# STATE OF VERMONT AGENCY OF TRANSPORTATION

## PROPOSED IMPROVEMENT TOWNS OF TROY AND NEWPORT COUNTY OF ORLEANS VT ROUTE 105

RECORD PLANS	
CONTRACTOR:	PIKE INDUSTRIES, INC. - BERLIN, VT
RESIDENT ENGINEER:	KEVIN MCCLURE
CONSTRUCTION BEGAN:	APRIL 19, 2010
CONSTRUCTION COMPLETE:	OCTOBER 11, 2010
RECORD PLANS BY:	KEVIN MCCLURE & C. PIERCE
I HEREBY CERTIFY THAT ALL THE CONSTRUCTION REQUIRED BY THIS SET OF DRAWINGS HAS BEEN ACCOMPLISHED AS INDICATED HEREIN.	
BY <u>Kevin McClure</u>	RESIDENT ENGINEER
DATE <u>9-1-11</u>	
NOTE: Any further information concerning final quantities, amounts or other details relative to this project may be found at Central Files in the electronic archives.

DIRECTOR OF PROGRAM DEVELOPMENT	
APPROVED <u>[Signature]</u>	DATE <u>7-20-09</u>
PROJECT MANAGER : TED DOMEY	
PROJECT NAME : TROY-NEWPORT	
PROJECT NUMBER : STP 2613(1)	
SHEET 1 OF 31 SHEETS

ITEM DETAIL SUMMARY SHEET

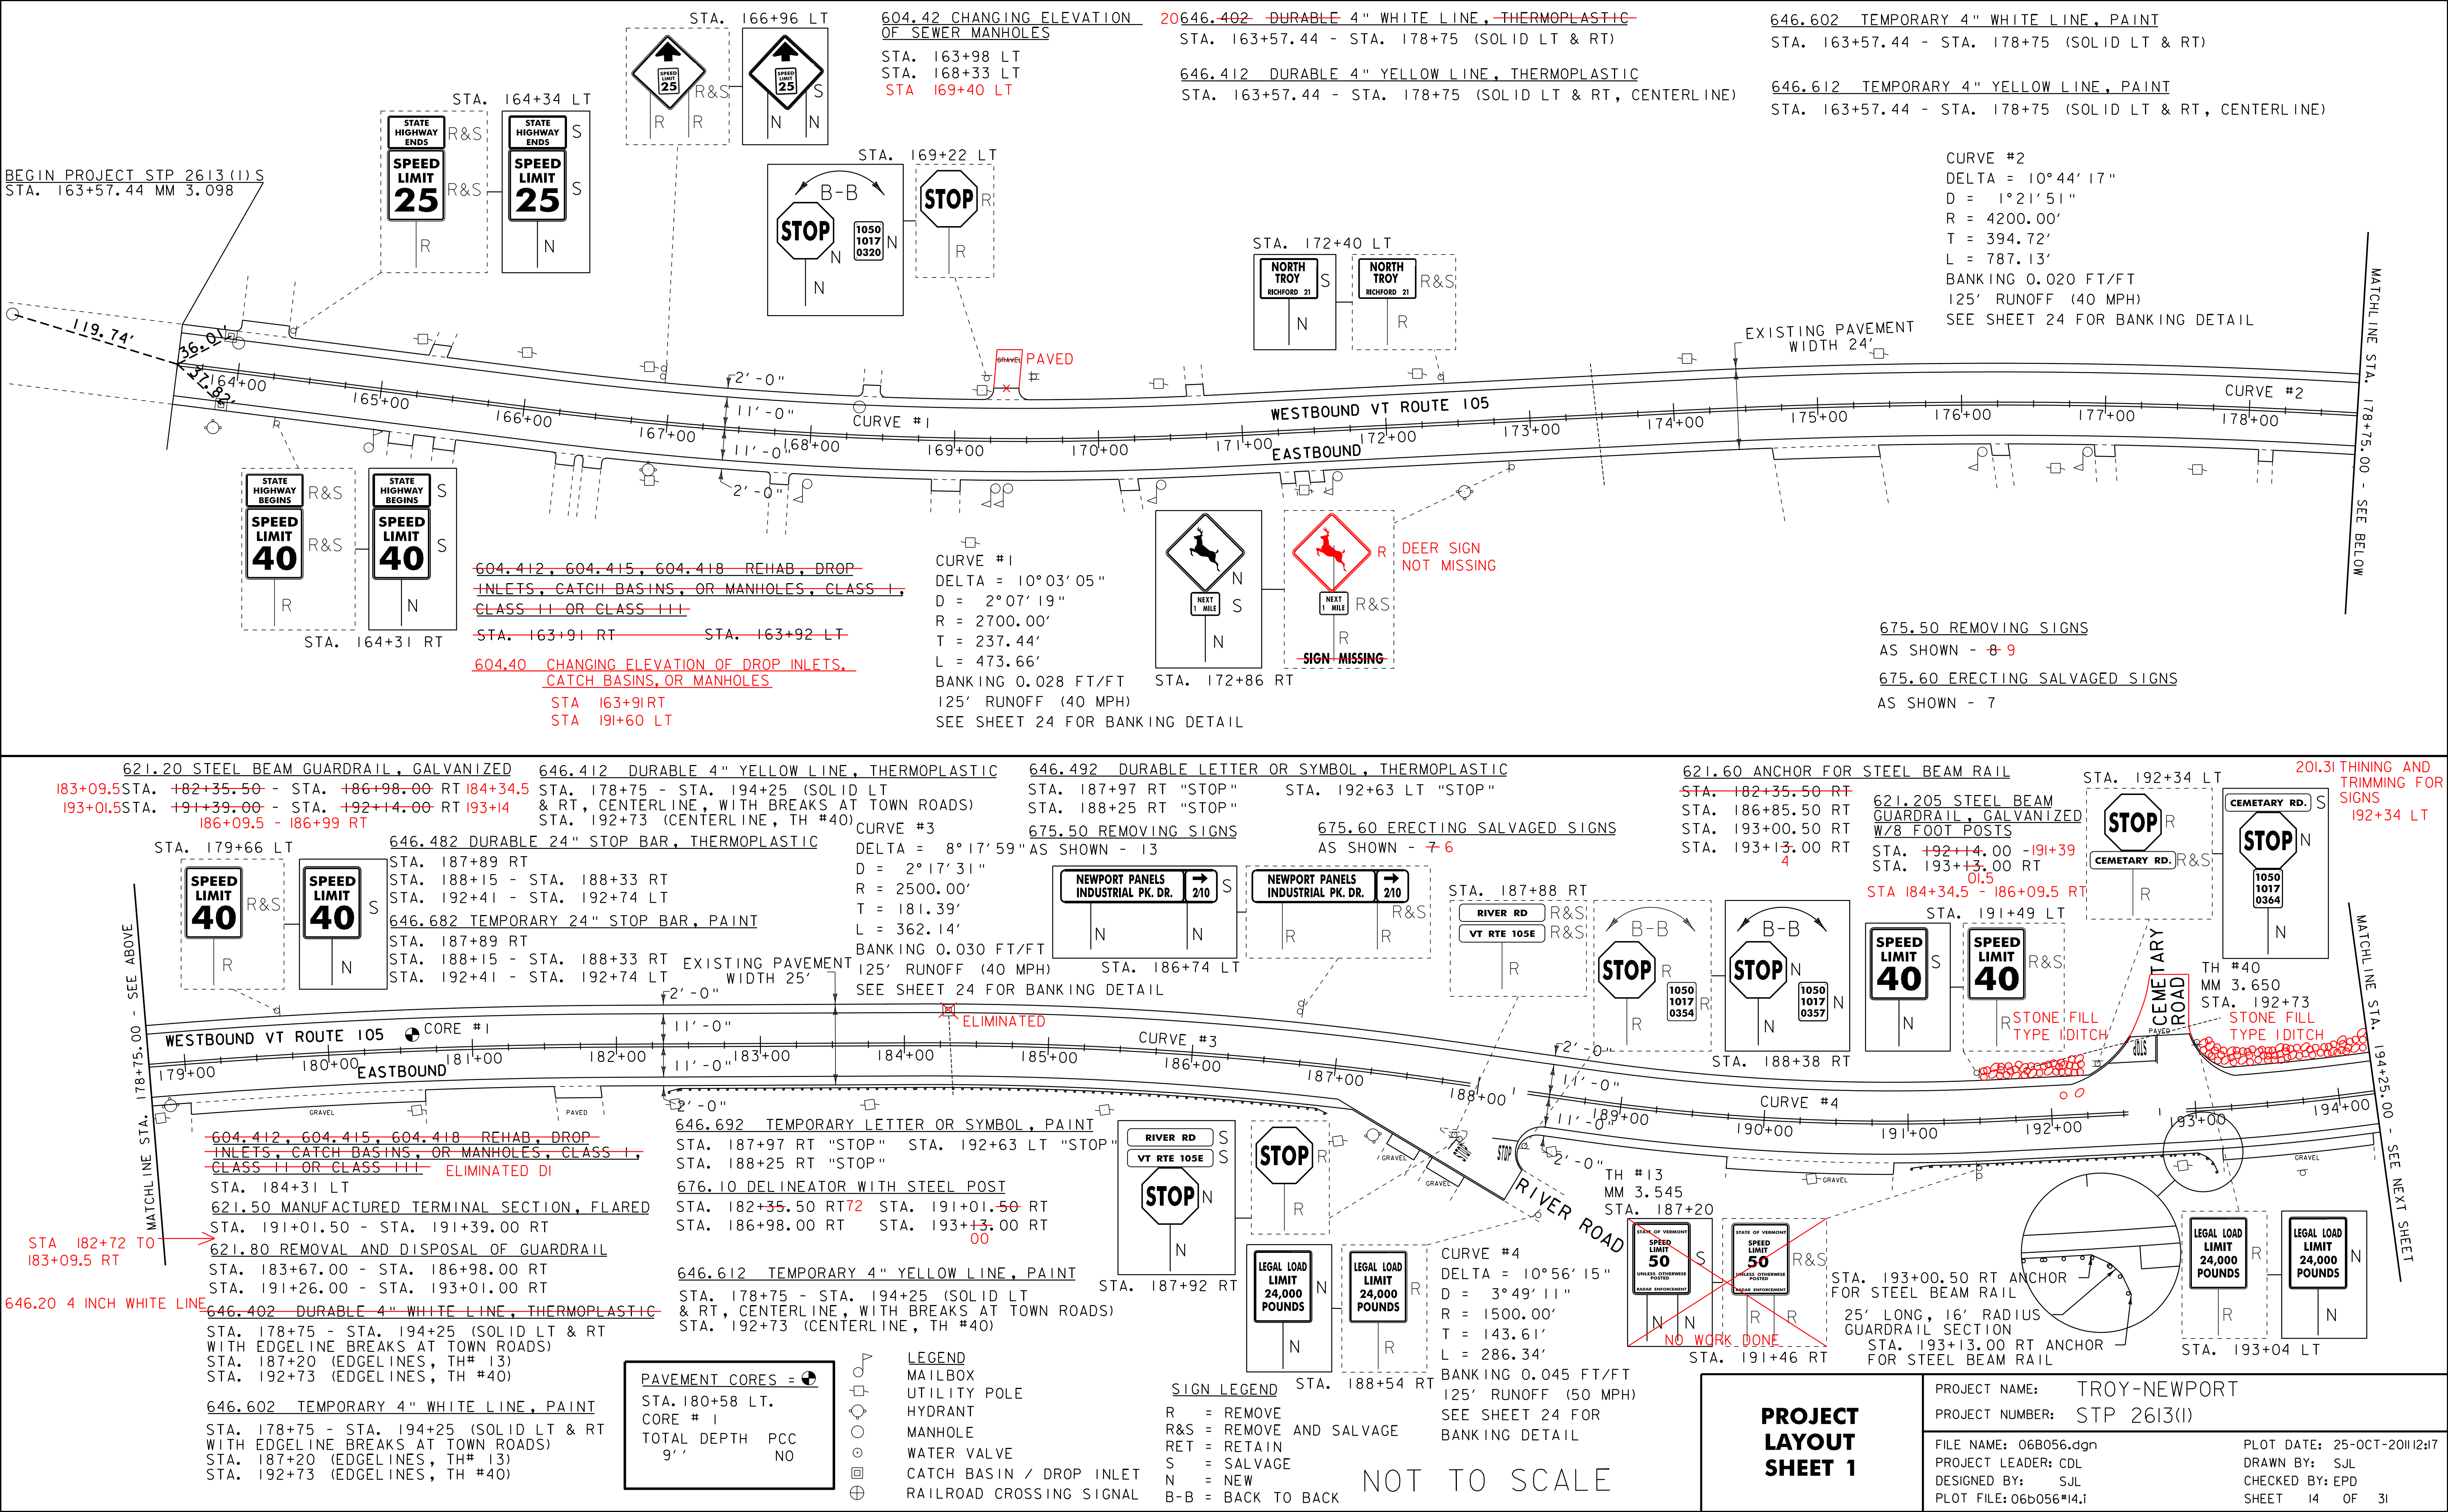
163+98		LT										1												
168+33		LT										1												
169+40												1		214.5										
182+35.50	186+98.00	RT												466.5	175		1	2		331	2	2	INSTALL <del>12' 6" LONG 16' RADIUS WITH ANCHOR AT MTS AT</del> STA. 182+35.50 AND <del>STA. 186+85.50</del> ANCHOR AT 186+85.5	
191+01.50	193+13.00	RT	25		5									89.9	100		1	2		175	2	2	INSTALL FLARED MTS AT STA. 191+01.50 AND 25' LONG, 16' RAD. WITH ANCHORS AT STA. 193+00.50 AND STA. 193+13.00	
298+89.00	301+89.00	LT	50		10									237.5						275	2	2	INSTALL FLARED MTS AT STA. <del>289+89.00</del> AND 298+89 STA. <del>301+51.50</del>	
302+43.00	303+02.00	RT	25		5																			
303+57.00	304+57.00	RT	50		10																			
NEWPORT																								
0+00	126+45.60	LT&RT		1127									30										ESTIMATED QUANTITY TO BE USED AS DIRECTED BY THE RESIDENT ENGINEER	
8+10.00	10+22.50	LT	25		5	62.5	62.5							52.0										INSTALL FLARED MTS AT STA. 8+10.00 AND 25' LONG, 16' RADIUS WITH ANCHORS AT STA. 10+10.00 AND STA. 10+22.50

8+10.00	10+10.00	RT	50		10	62.5	62.5							12.5		95	2			100	2	2	INSTALL FLARED MTS AT STA. 8+10.00 AND STA. 9+72.50	
26+08.00	33+58.00	RT	50		10									677				2					INSTALL FLARED MTS AT STA. 26+08.00 AND <del>STA. 33+20.50</del> 2 ANCHORS STA 32+92.5 33+20	
32+22.00	34+11.50	LT	25		5									164.5			1	2		200	2	2	INSTALL FLARED MTS AT STA. 32+22.00 AND 25' LONG, 16' RADIUS WITH ANCHORS AT STA. 33+99.00 AND STA. 34+11.50	
50+74.00	53+36.50	RT	25		5									175			1		1	137.5	1	1	INSTALL FLARED MTS AT STA. 50+74.00 ATTACH TO BR. #58 BRIDGE RAIL	
52+65.00	53+52.50	LT	25		5												1		1	87.5	1	1	INSTALL FLARED MTS AT STA. 52+65.00	
BRIDGE #58																								
54+46.00	55+46.00	RT	25		5									12.5			1		1	100	1	1	ATTACH TO BR. #58 BRIDGE RAIL INSTALL FLARED MTS AT STA. 55+08.50	
54+69.00	56+81.50	LT	25		5									125			1		1	100	1	1	ATTACH TO BR. #58 BRIDGE RAIL INSTALL FLARED MTS AT STA. 56+44.00

62+92.50	65+05.00	RT	50	41.3	10	43.75	43.75							0-37.5	102	86.25	2	1		37.5	2	2	INSTALL FLARED MTS AT STA. <del>62+92.50</del> AND STA. 64+67.50 AND ANCHOR 62+80	
63+20.00	65+95.00	LT	50		10	43.75	43.75							100		86.25	2			37.5	2	2	INSTALL FLARED MTS AT STA. 63+20.00 AND STA. 65+57.50	
118+73.00	<del>122+98.00</del>	LT	50		10									500						425	2	2	INSTALL FLARED MTS AT STA. 118+73.00 AND <del>STA. 122+60.50</del>	
119+90.00	124+40.00	RT	50		10									387.5						450	2	2	INSTALL FLARED MTS AT STA. 119+90.00 AND STA. 124+02.50	
<del>123+21.00</del>	124+46.00	LT	50		10									50						100	2	2	INSTALL FLARED MTS AT STA. <del>123+21.00</del> AND STA. 124+08.50	
SUBTOTAL			650	2931	130	212.50	212.50	+	+	+	+	2	72	2,910	100	362.5	23	8	4	3,256	28	28		
ROUNDING			-	-	-	12.5	12.5	-	-	-	-	-	-	90	-	12.5	-	-	-	44	-	-		
TOTAL			650	2931	130	225	225	+2	+	+	+	2	3	72	78	3,000	100	375	4	3,300	28	28

**PROJECT LAYOUT SHEET 2**

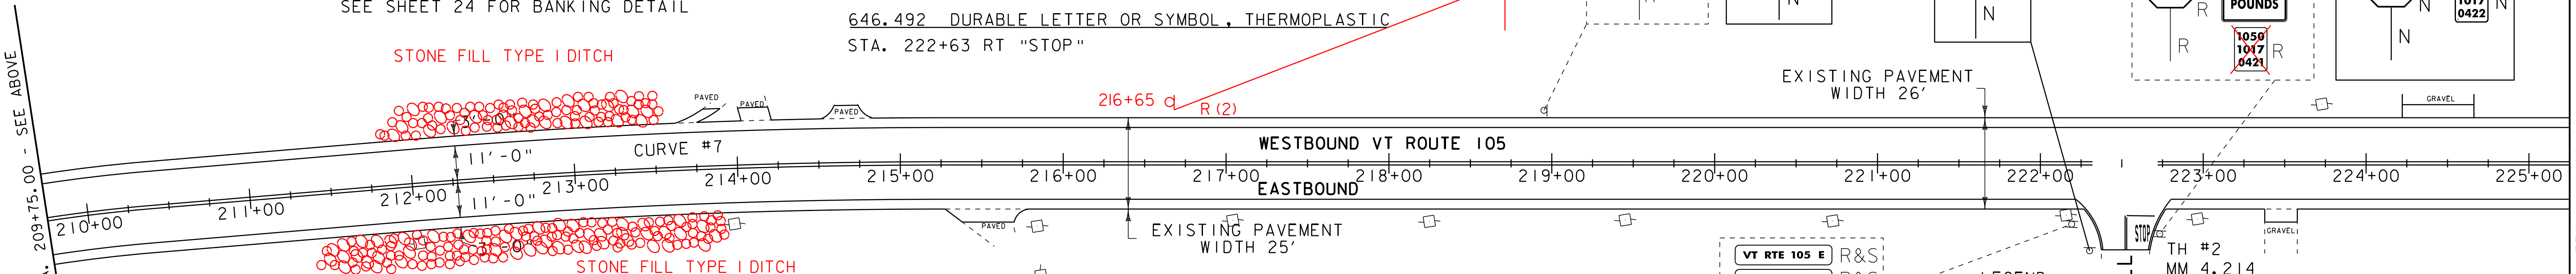
646.20 4 INCH WHITE LINE  
~~646.402 DURABLE 4" WHITE LINE, THERMOPLASTIC~~  
 STA. 194+25 - STA. 209+75 (SOLID LT & RT)

646.20 4 INCH WHITE LINE  
~~646.402 DURABLE 4" WHITE LINE, THERMOPLASTIC~~

**PROJECT LAYOUT SHEET 3**

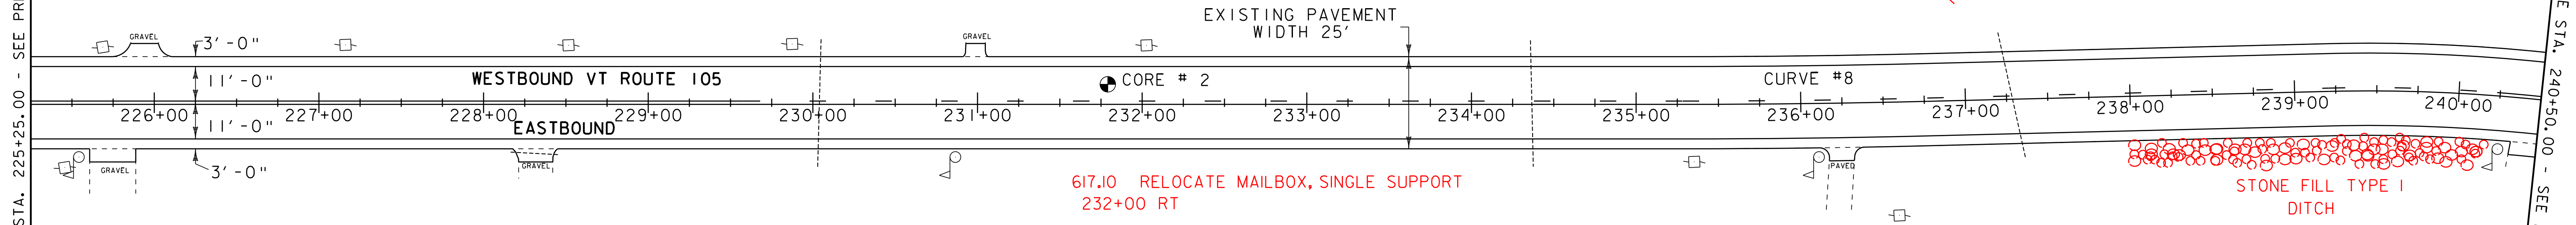
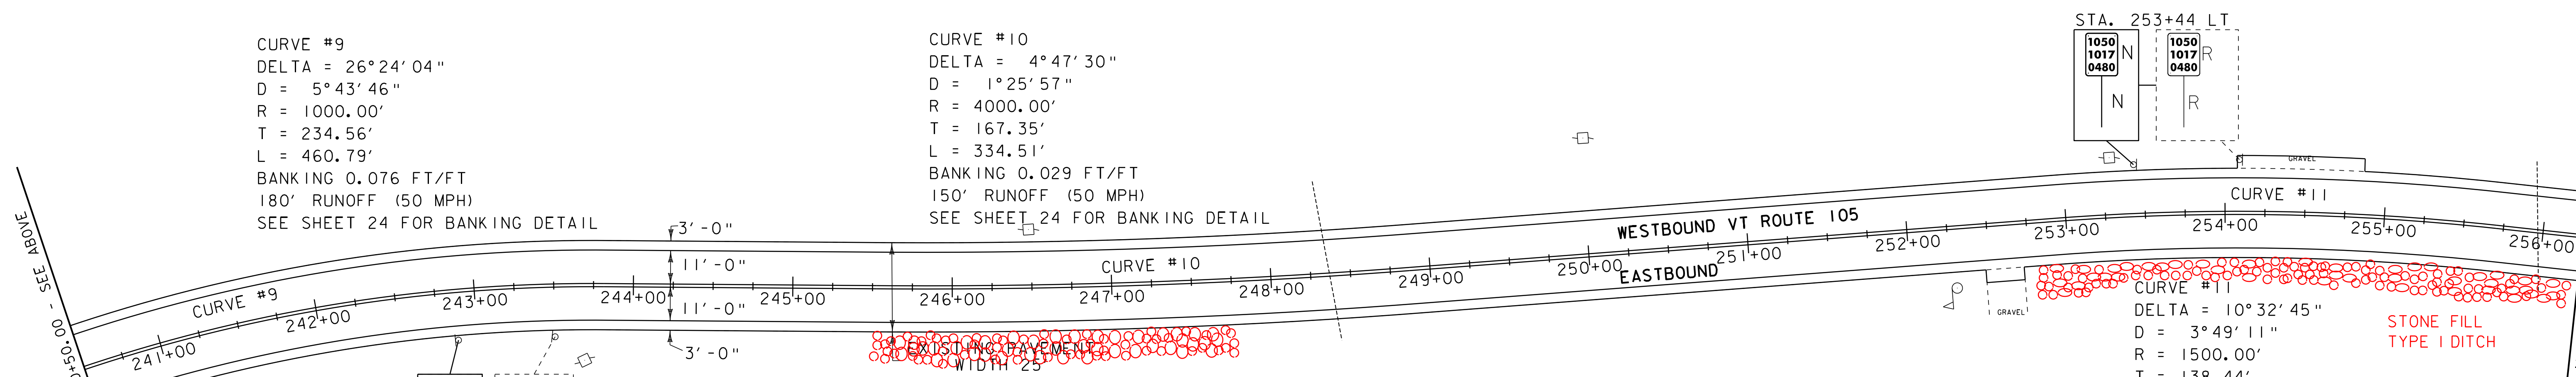
~~646.402 DURABLE 4" WHITE LINE, THERMOPLASTIC~~  
STA. 225+25 - STA. 240+50 (SOLID LT & RT)

~~CURVE #8  
DELTA = 1°25'09"  
D = 0°57'18"  
R = 6000.00'  
T = 74.31'  
L = 148.62'  
BANKING 0.021 FT/FT  
150' RUNOFF (50 MPH)  
SEE SHEET 24 FOR BANKING DETAIL~~  
ELIMINATED  
SEE W.O.#2

~~646.402 DURABLE 4" WHITE LINE, THERMOPLASTIC~~  
STA. 240+50 - STA. 256+25 (SOLID LT & RT)

**PROJECT LAYOUT SHEET 7**

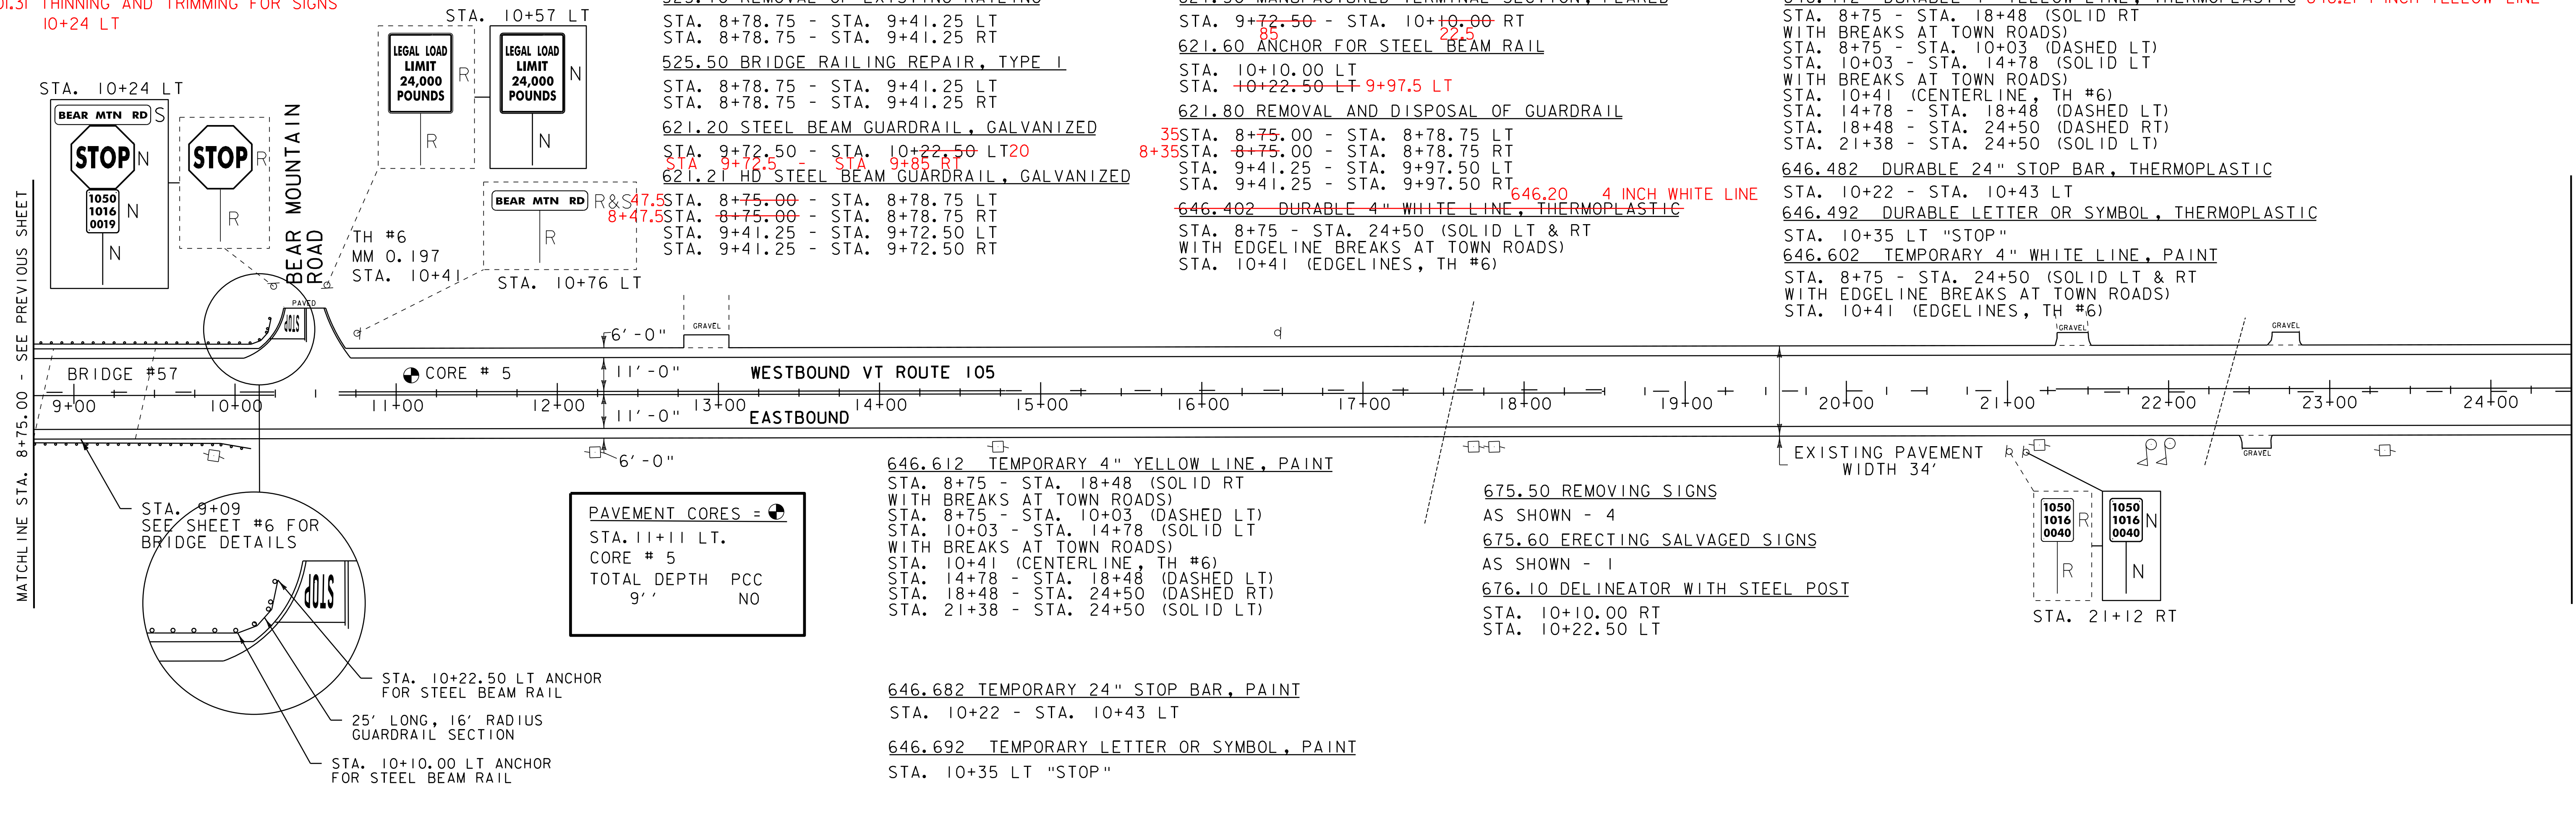
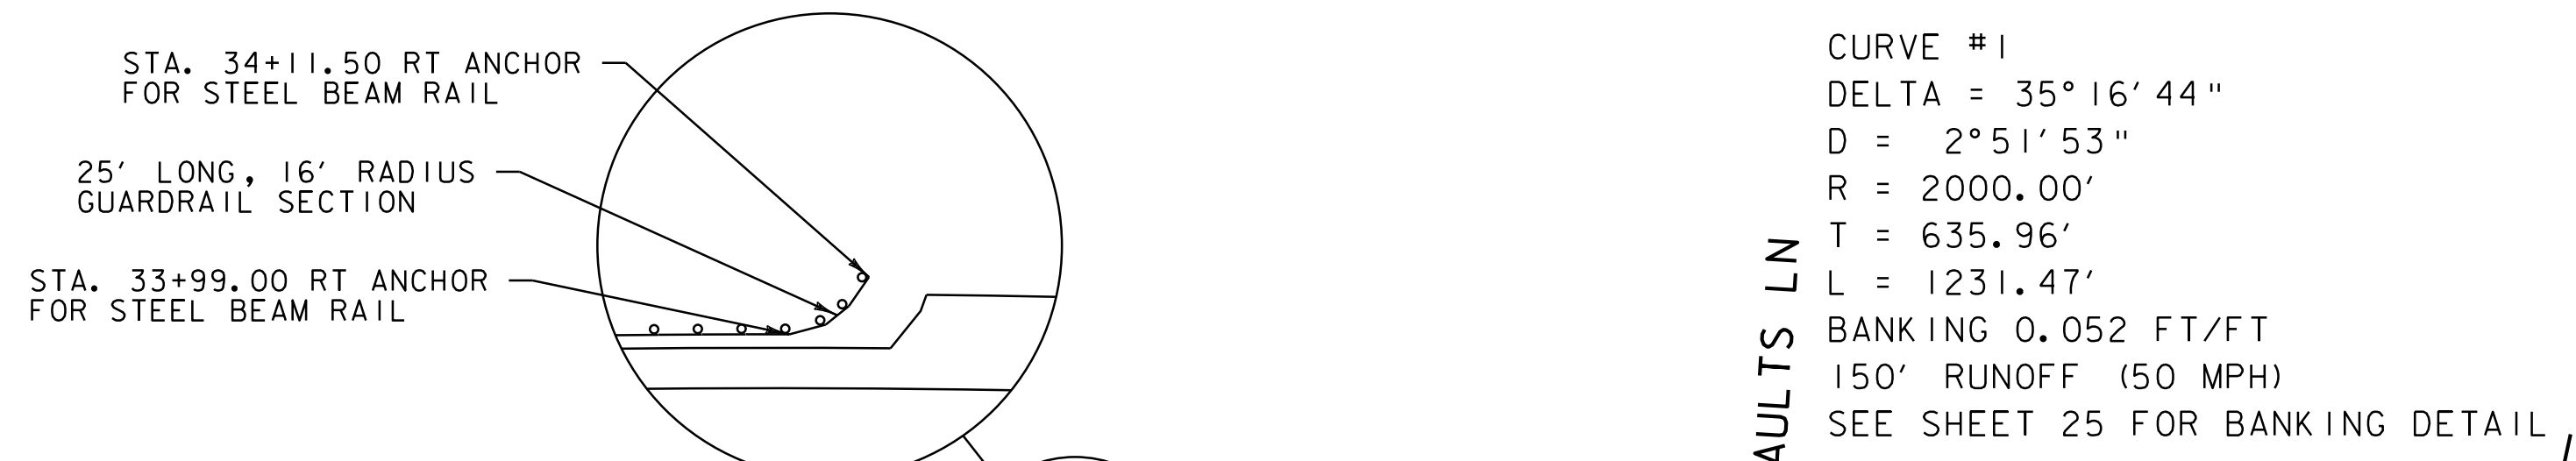
621.50 MANUFACTURED TERMINAL SECTION, FLARED  
 STA. 26+08.00 - STA. 26+45.50 RT  
 STA. 32+22.00 - STA. 32+59.50 LT  
~~STA. 33+20.50 - STA. 33+58.00 RT~~
